SIKA ROOFING ROOF CONDITION REPORT

PROJECT: Middle Warehouse Balconies, 2025
PROJECT REF: 0536183
DATE: 28 April 2025

1 0536183 MIDDLE WAREHOUSE BALCONIES, 2025 ROOF CONDITION REPORT

1.2.3 HISTORICAL REPAIRS

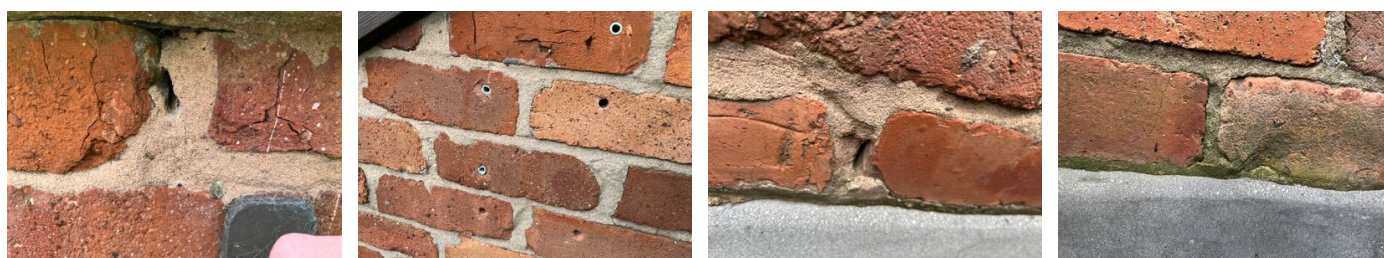
Historical Repairs: Local areas on both terraces show examples of patch repairs, affirming the reports that the roof has experienced leaks in the past. These will need to be suitably removed to allow the new system to be installed.

1.2.5 DRAINAGE

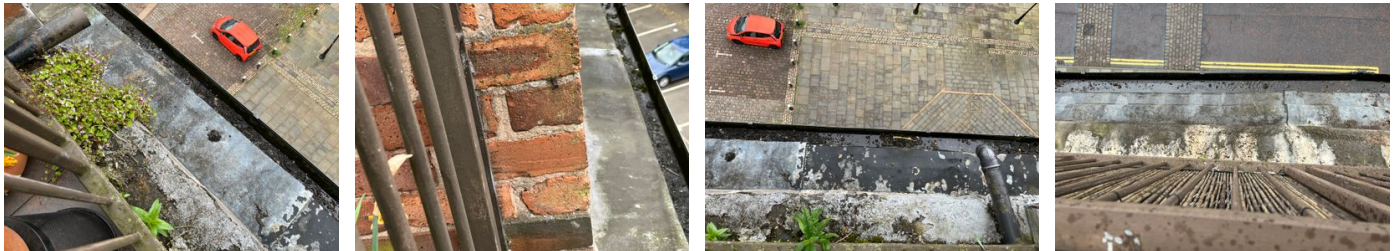
Drainage: The roof falls to an external gutter, over a drip edge. This detail is suitable to remain but the waterproofing of the flashings needs to be updated to prevent water tracking through this area. This should be coated in its entirety.
